KELLY AFB
TEXAS

DRAFT MEETING MINUTES

**KELLY AFB TECHNICAL REVIEW SUBCOMMITTEE (TRS)
TO THE RESTORATION ADVISORY BOARD (RAB)**

14 August 2001, Las Palmas Library
515 Castroville Road
Dr. Gene Lené, TRS Chairman

DRAFT Metals, Chlorobenzene, Benzene 2000

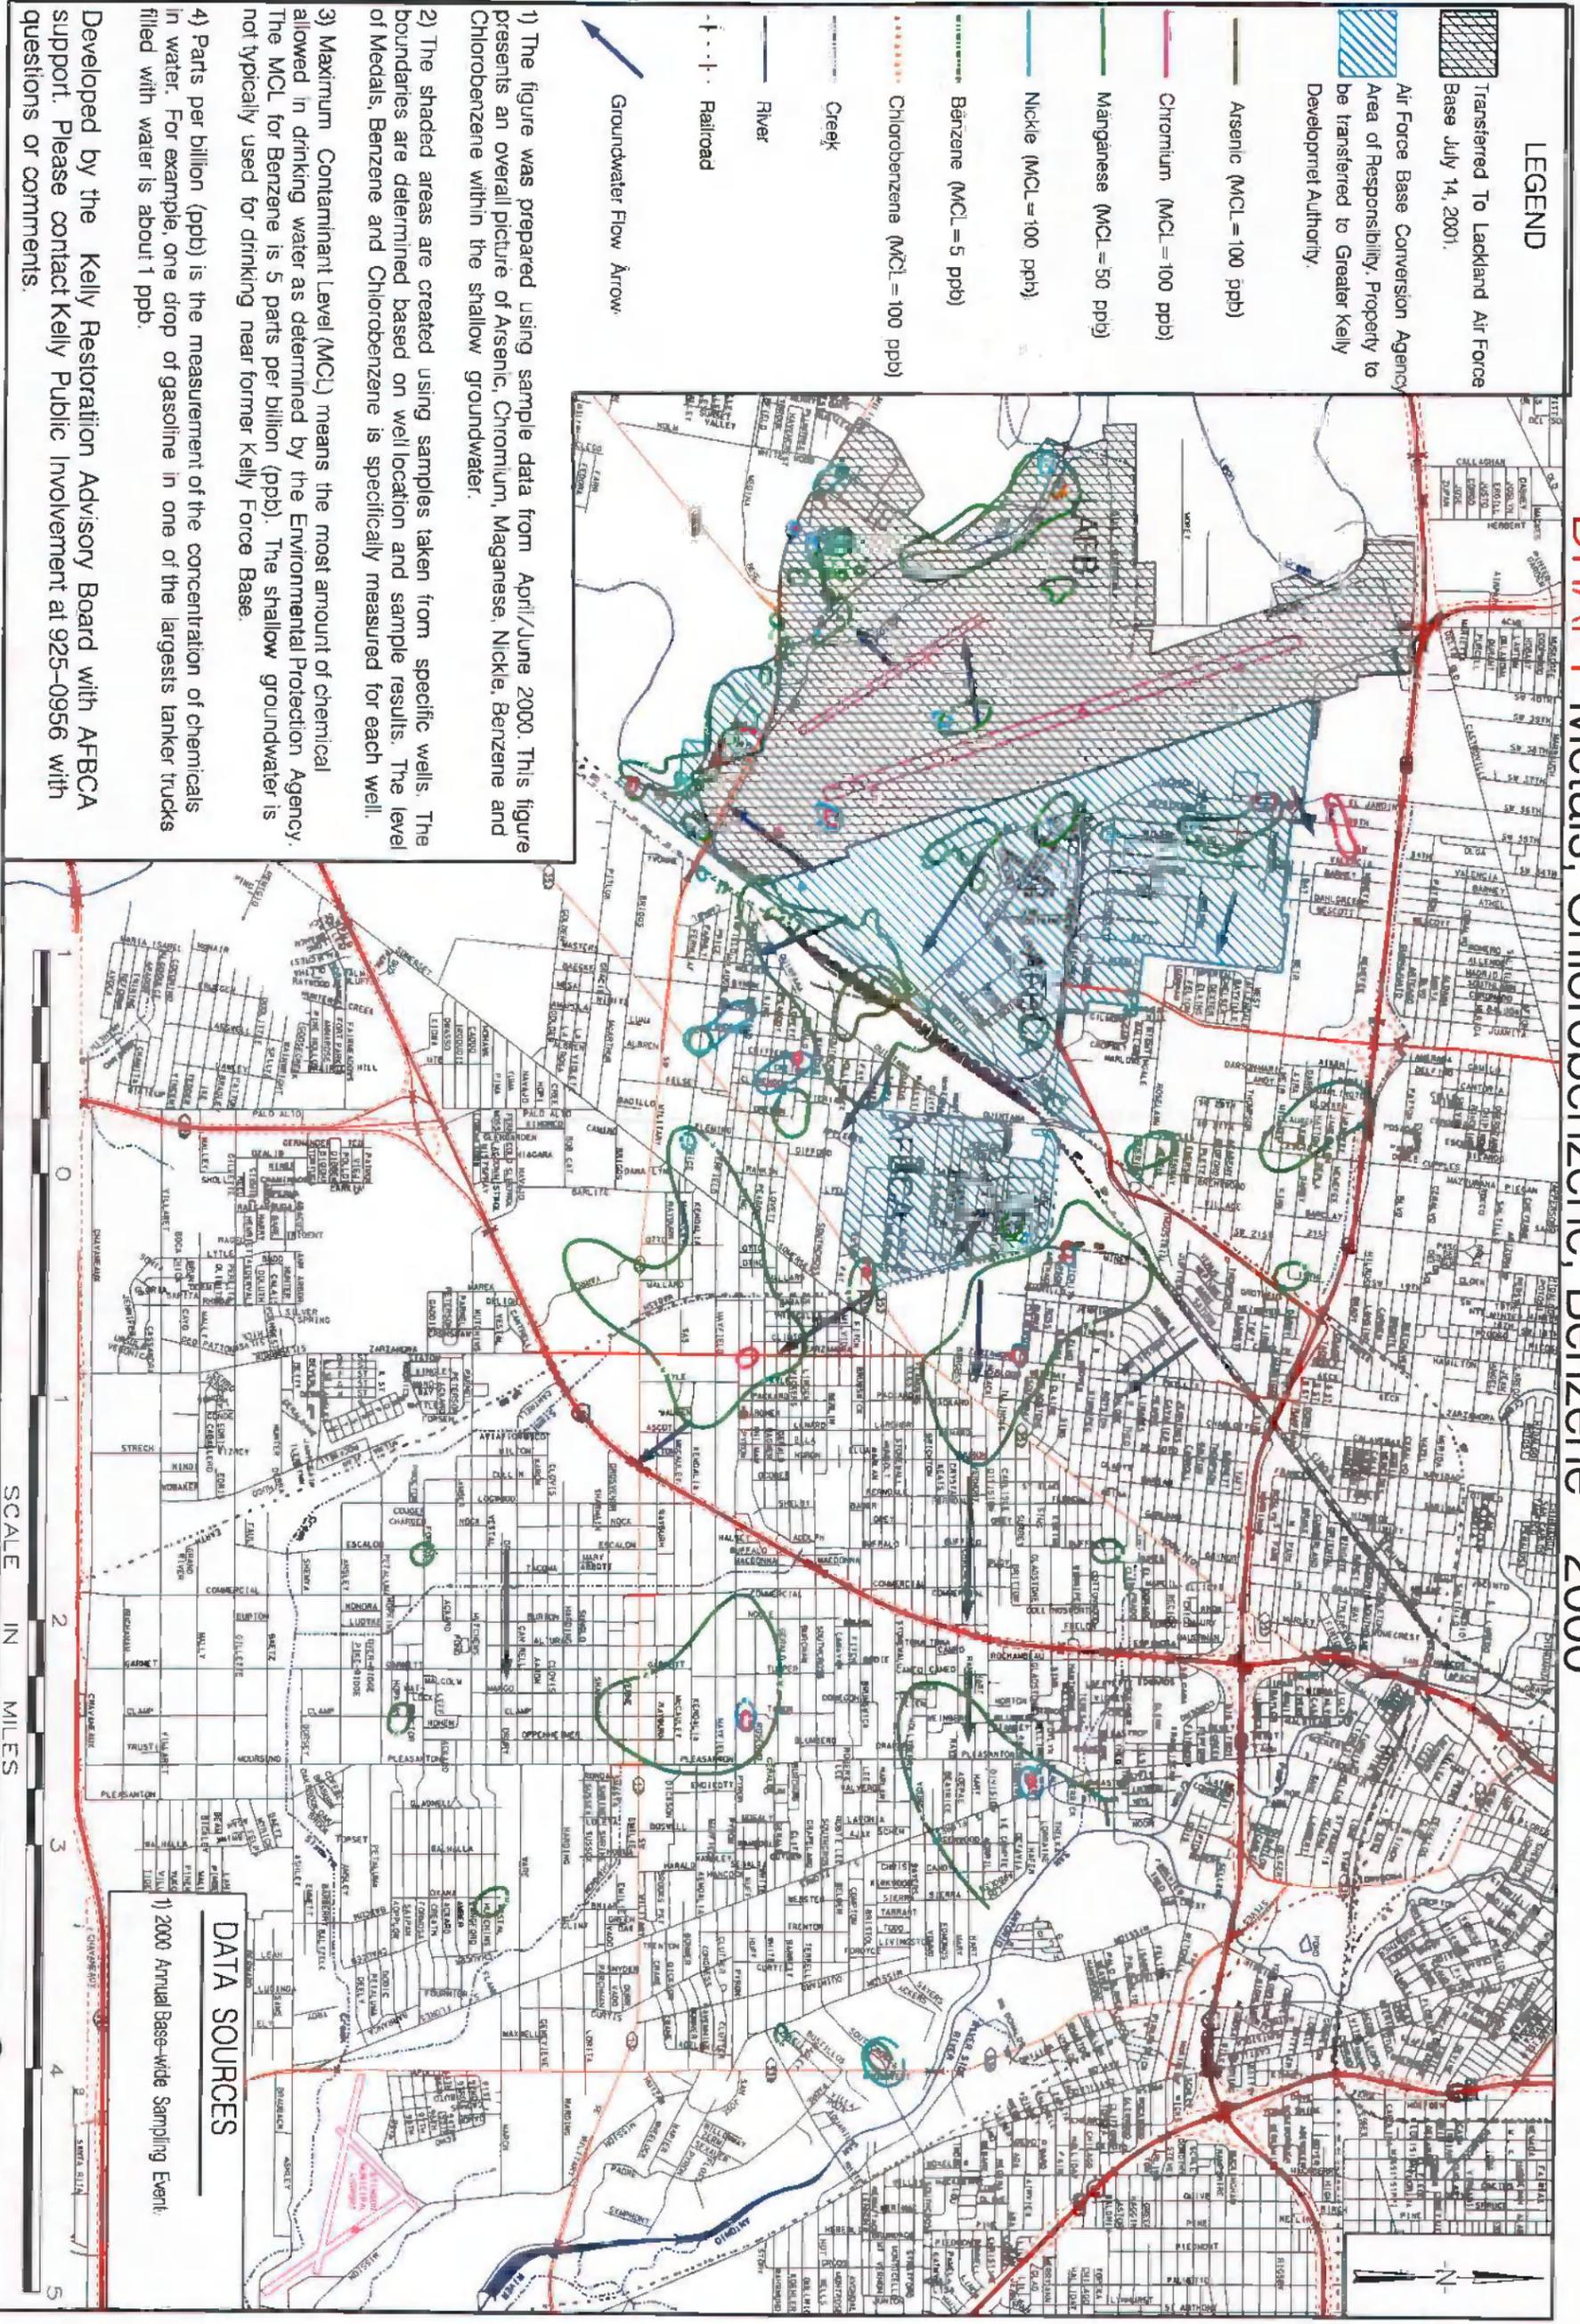
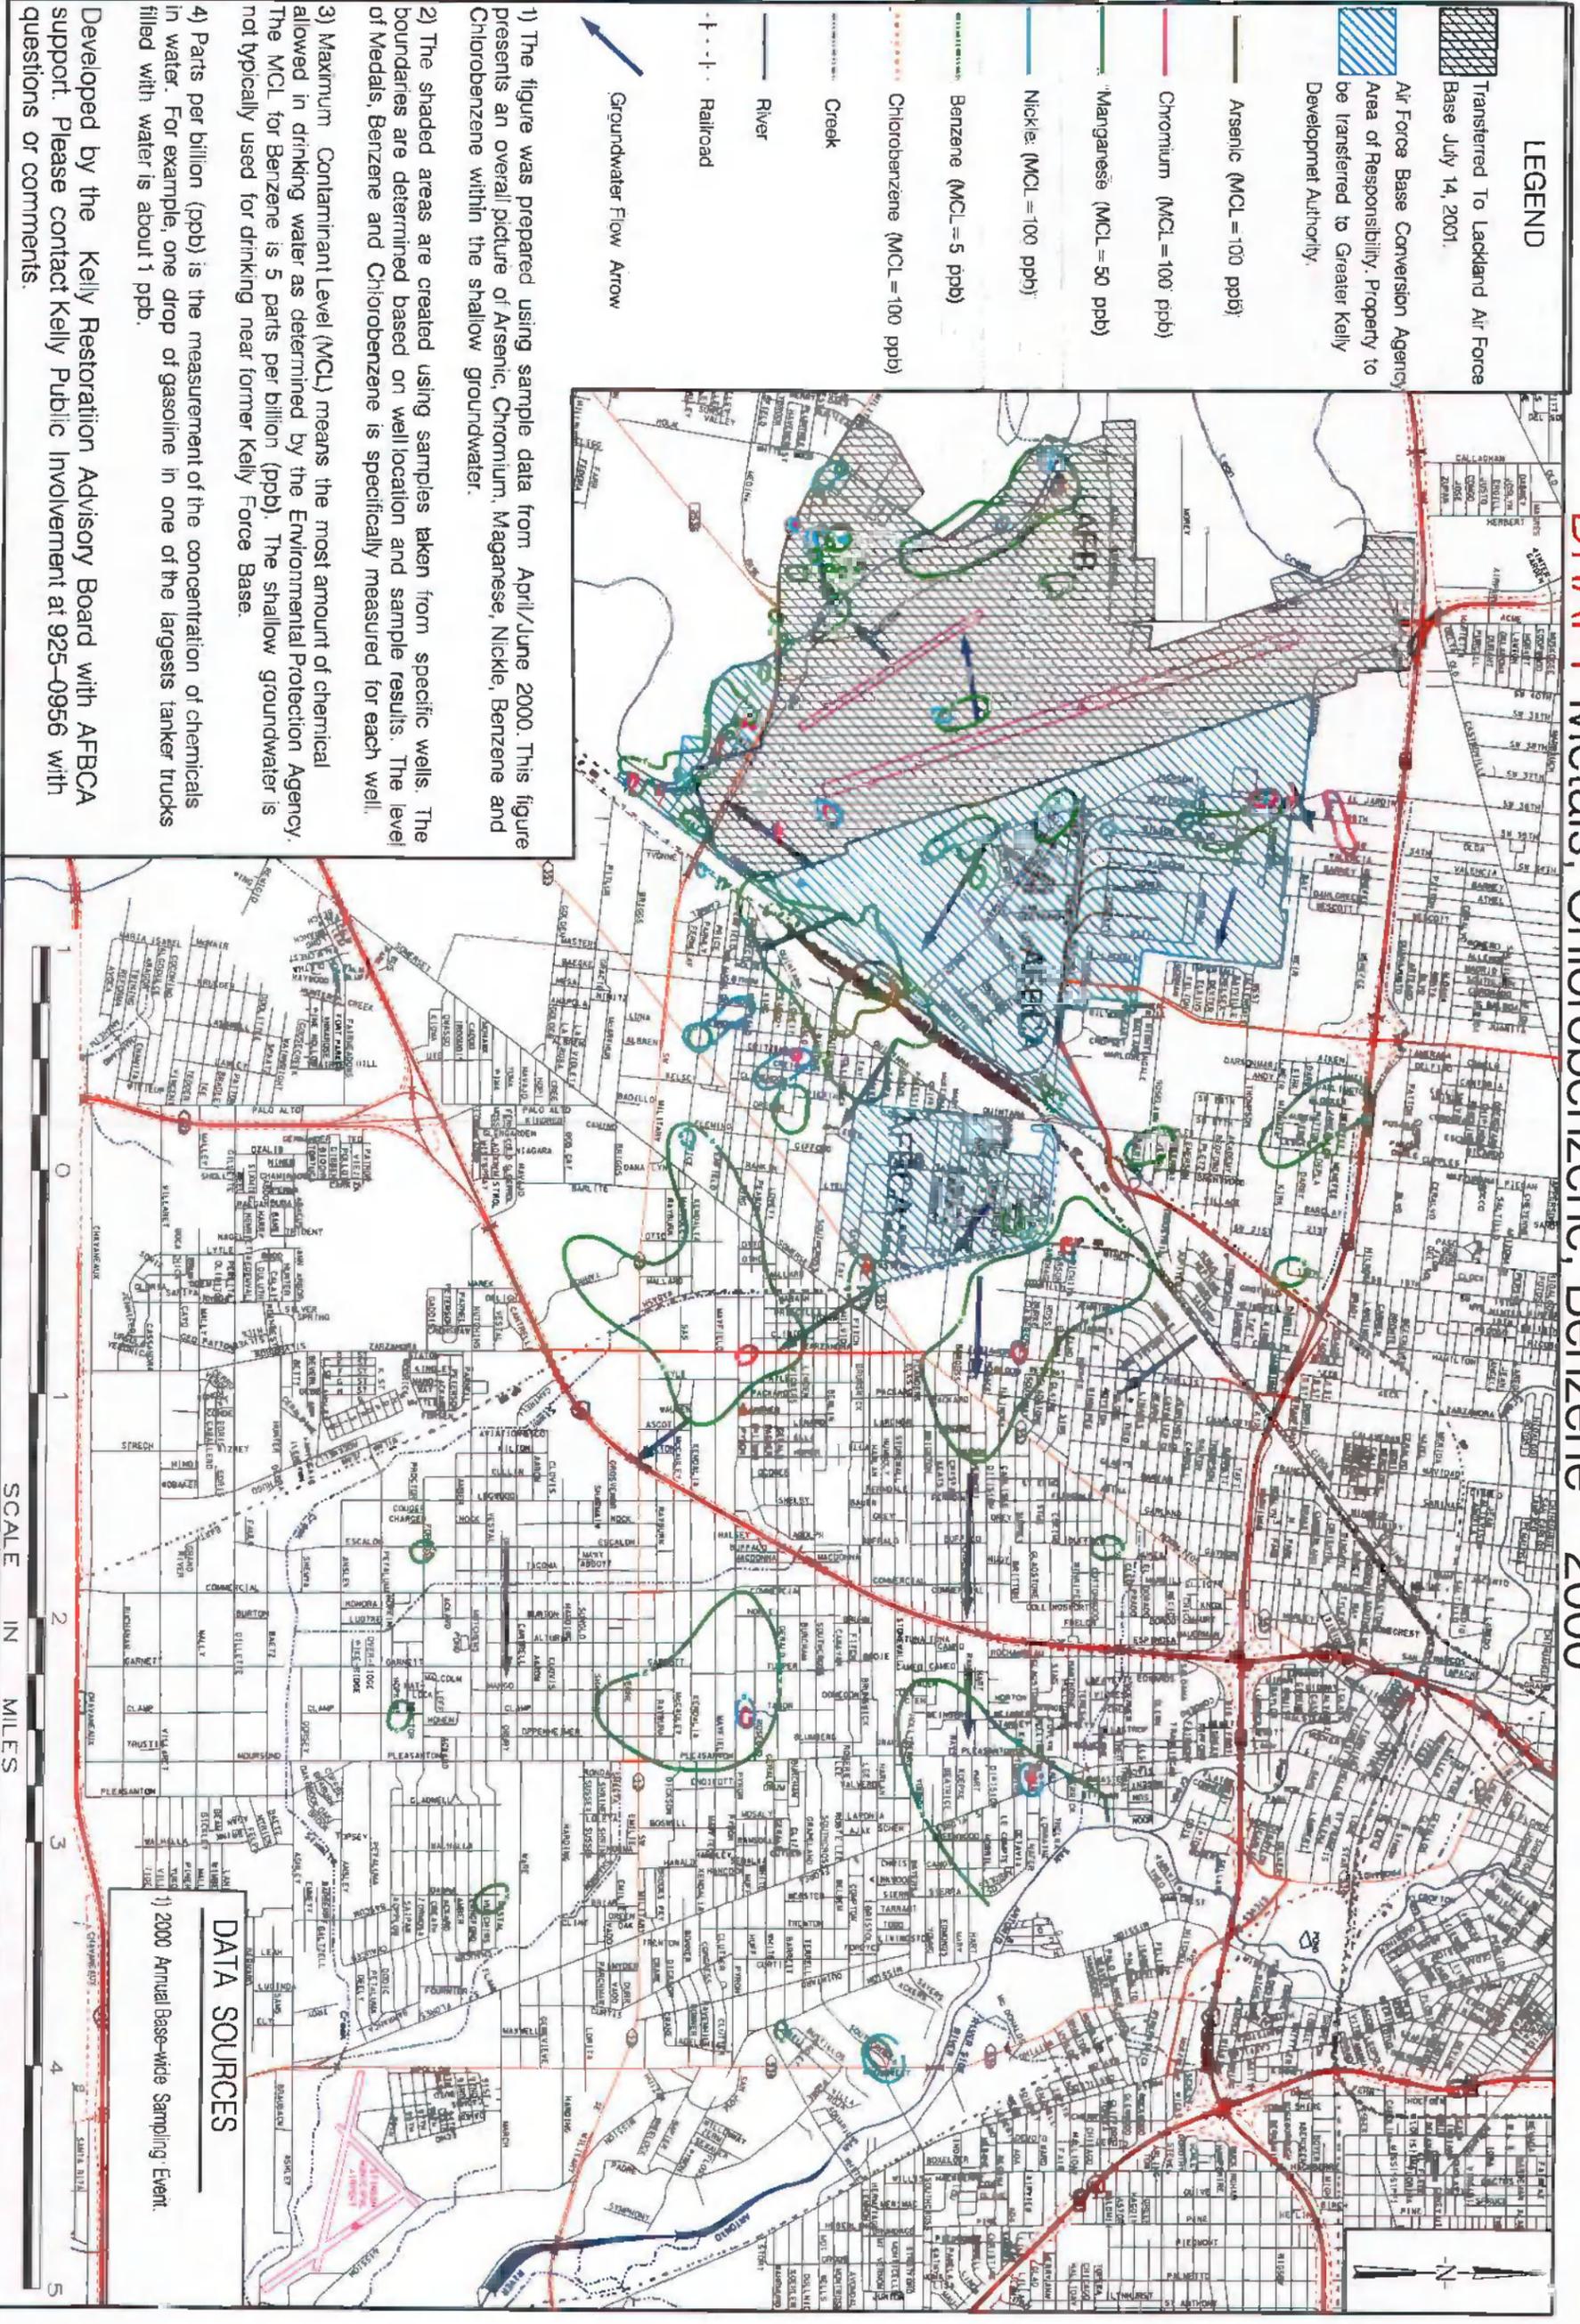
- The dashed green lines on the TCE map should match – make estimated lines the same style
- Replace “typically” with “known to be” in the last sentence of paragraph 4 in each map
- Fix typos on all three maps
- Change the explanation of ppb from the gasoline tanker example to the Olympic swimming pool example
- Change the term “shaded areas” to “contoured areas” in paragraph two of all three maps
- Place the words “for example” in front of the second line in paragraph two of the Metals map
